CIRNAC Comments to NIRB Re: Comment Request for Agnico Eagle Mines Limited's Meadowbank Complex 2022 Annual Report

June 23, 2023

Re: Comment Request for Agnico Eagle Mines Limited's Meadowbank Complex Project 2022 Annual Report

(As extracted from Figure 4-4 of Appendix 13, Appendix D of the 2022 Annual Report)

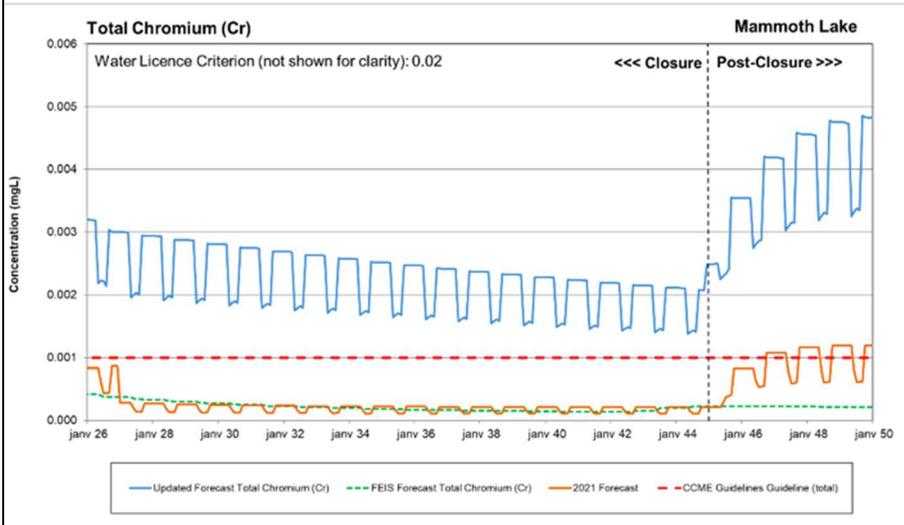
Technical Review Comment Number:	CIRNAC #7
Subject:	Whale Tail Revised Water Quality Predictions
Reference:	<ul style="list-style-type: none"> • Meadowbank Complex 2022 Annual Report: Appendix 13, Appendix D • Meadowbank Complex 2021 Annual Report: Appendix 13, Appendix D • Final Environmental Impact Statement Addendum for the Whale Tail Pit Expansion Project (2018)
Background/Rationale:	<p>Appendix 13 (Appendix D) of the 2022 Annual Report presents updated water quality predictions for the Whale Tail site. The predictions for some parameters are substantively different from predictions presented in the FEIS Addendum for the Whale Tail Pit Expansion Project. Notably, the following parameters are now predicted to exceed the FEIS values in Mammoth Lake during the post-closure phase: cadmium, chromium, copper, iron, manganese, nickel, selenium, zinc, phosphorous, nitrate and chloride.</p> <p>In addition to exceeding FEIS predictions, some parameters are also predicted to be above the predictions presented in the 2021 Annual Report and, in some instances, above the applicable environmental quality criteria (e.g., CCME criteria for the protection of freshwater aquatic life). This situation is demonstrated in the following two plots for total phosphorous and total cadmium. In both cases, revised predictions are well above: a) the FEIS predictions; b) the 2021 predictions; and, most importantly c) the applicable CCME criteria during the post-closure phase.</p> <div data-bbox="581 1157 1468 1671" data-label="Figure"> </div> <p>(As extracted from Figure 4-3 of Appendix 13, Appendix D of the 2022 Annual Report)</p>

Technical Review Comment Number:	CIRNAC #7
	<p><i>model forecasted concentrations that are generally higher than the FEIS forecasted values.</i>” Despite this acknowledgement, the 2022 Annual Report presents limited information regarding the factors that are contributing to the predicted increases. For example, it is unclear whether the increases are attributable to revised modelling assumptions or site conditions that are worse than originally expected (e.g., elevated seepage loading rates).</p> <p>Furthermore, with regard to predictions that exceed the CCME criteria during post-closure (e.g., cadmium and phosphorous), the 2022 Annual Report presents limited information regarding the potential implications to the closure strategies for the site. To the contrary, the Annual Report states: “<i>At closure, no water treatment is forecasted to be required.</i>” This conclusion appears to be inconsistent with predicted water quality exceedances during the post-closure phase.</p>

Recommendation to Address Issues:	<p>Given the limited time prior to the initiation of closure (i.e., 2026), CIRNAC recommends that AEM respond to the following requests on a priority basis:</p> <ol style="list-style-type: none"> 1. Provide a detailed table describing the factors that contributed to 2022 water quality predictions being higher than one or more of the following: a) FEIS predictions; b) predictions from 2021; and c) predictions that exceed environmental quality criteria. 2. Describe why there is a high-degree of variability between the 2021 and 2022 predictions; 3. For any parameters that are predicted to exceed 75% of the environmental quality criteria during post-closure, describe the approaches that will be taken to ensure significant adverse impacts do not occur. 4. Describe the studies that AEM will undertake between now and the finalization of the closure plan to verify the accuracy of water quality predictions. 5. Describe if and how the higher than originally anticipated water quality predictions will affect closure strategies for the site.

(As extracted from Figure 4-1 of Appendix 13, Appendix D of the 2022 Annual Report)

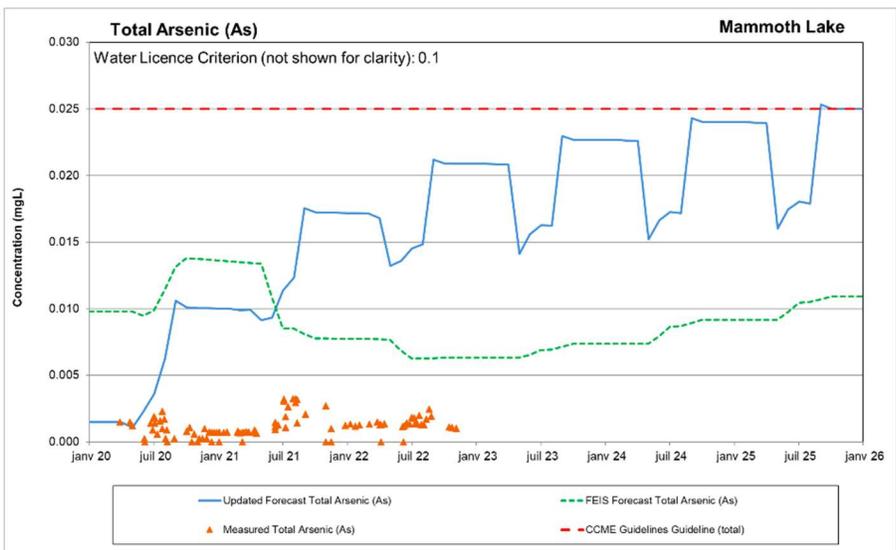
In addition to the increases noted above, arsenic concentrations in Mammoth Lake (as shown in the following figure) are now predicted to be well above the FEIS Addendum predictions. They are also predicted to be approaching the applicable CCME effluent quality criterion (0.025 mg/L) at the time of closure (i.e., three years from now, in 2026).

(As extracted from Figure 4-1 of Appendix 13, Appendix D of the 2022 Annual Report)

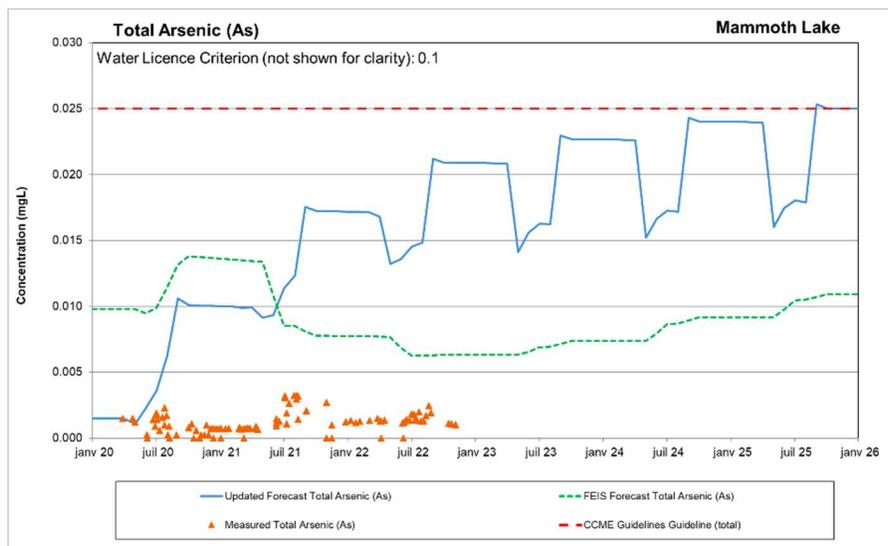
those that were reached for the FEIS. However, the “order of magnitude” approach is not sufficient for an operating mine that is approaching closure, particularly in instances where parameters are predicted to approach and exceed applicable environmental quality criteria. To illustrate, the following figure indicates that arsenic is predicted to approach the CCME effluent quality criterion (0.025 mg/L). Given that predictions are only accurate to within an order of magnitude, actual arsenic concentrations could reach levels that are ten-times the CCME criterion. The proximity of the current predictions to the criterion therefore represent a potential concern that warrants more detailed modelling.

CIRNAC has cited this concern on multiple occasions, most recently in its submission on the 2021 Annual Report to the NWB (TRC #1). In response to that comment, AEM indicated (in a May 29, 2023 letter to NWB) that appropriate modifications would be made to the 2022 Annual Report. Based on our review of the 2022 Annual Reports submitted to NIRB and NWB, CIRNAC was unable to identify any evidence to demonstrate that the recommended changes had been made.

Technical Review Comment Number:	CIRNAC #8
Recommendation to Address Issues:	<p>Given the limited time prior to the initiation of closure (i.e., 2026), CIRNAC recommends that AEM, on a priority basis, revisit the water quality modelling assumptions and approaches used for both Meadowbank and Whale Tail to ensure all future project decisions (particularly closure) are informed by sufficiently accurate predictions. At minimum, factors to consider when revisiting the assumptions and approaches should include:</p> <ol style="list-style-type: none"> 1. using monthly (or smaller) time steps for all model inputs instead of the current one-year time step; 2. performing hydrodynamic modelling of receivers instead of assuming fully mixed conditions; 3. performing sensitivity analyses to accurately capture the range of uncertainty associated with water quality predictions; and, 4. expanding efforts to characterize loadings from pit walls.
